HOLDOVER
REVISED
LUSANN WOODS SUBDIVISION

APPLICATION NUMBER Holdover DATE April 17, 2003

DETAIL SITE PLAN

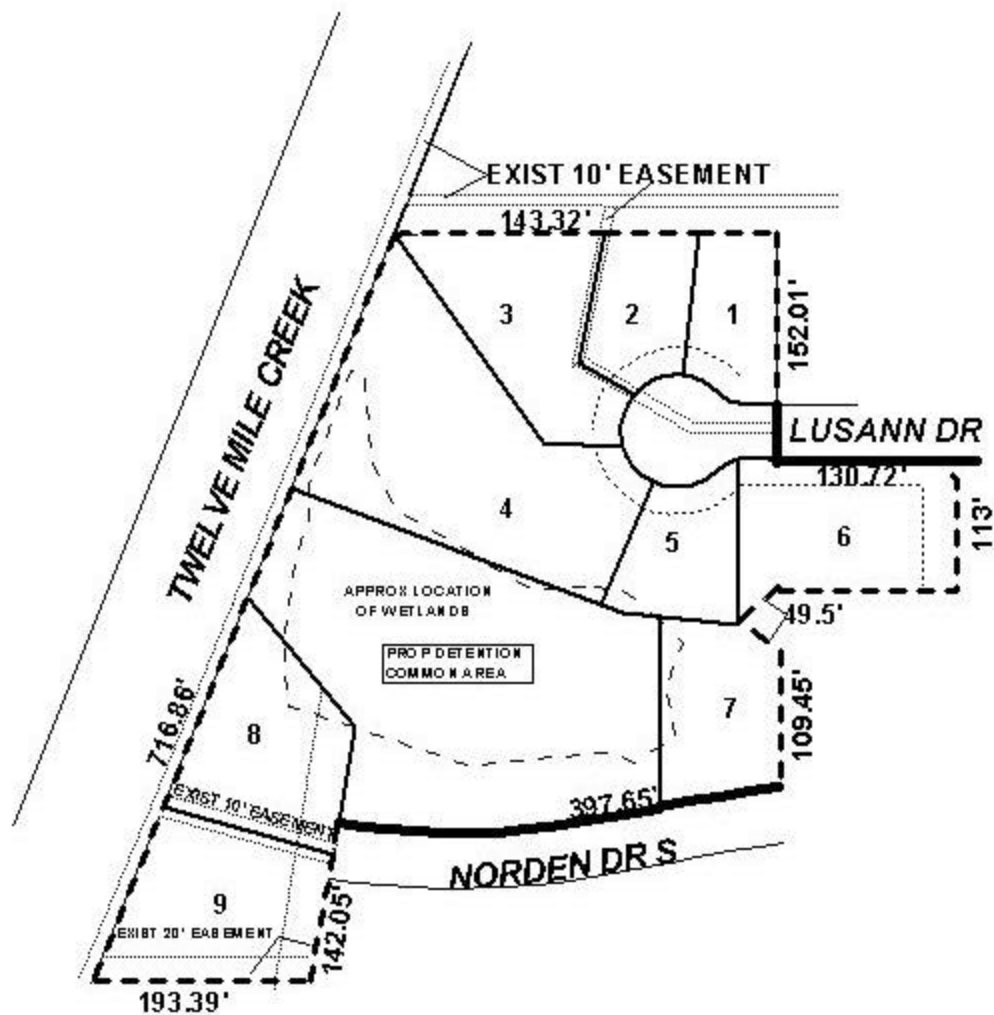
Engineering Comments: Common Area for stormwater detention not shown on plat. Full compliance with Stormwater Management Ordinance required, including creation of Property Owners Assoc. to maintain common areas. Cul de sac(s) to be completed to COM Standards and must comply with all stormwater and flood control ordinances. Any work performed in the right-of-way will require a right-of-way permit.

There are a few concerns related with this application. First, according to the City Engineering Department, the site must provide stormwater detention for the development. As proposed, the plat does not reflect an area to provide the required detention, thus making the lots subject to a different configuration.

Second, the applicant proposes to have Lots 7 and 8 front Norden Drive South, which is a dead end street. The construction and dedication of a cul-de-sac, to city standards, should be required. This construction would modify the plat layout; therefore, the submission of a revised plat would be required.

The applicant submitted a revised plat illustrating wetlands, common area, and the incorporation of additional property into the subdivision. This information was submitted past the deadline, thus not allowing the staff to perform an adequate review. The staff will present comments at the meeting.

Based upon the preceding, this application is recommended for holdover to allow the applicant to address the concerns identified in this report. This information should be submitted by April 7th to be considered at the Commission's April 17th meeting.
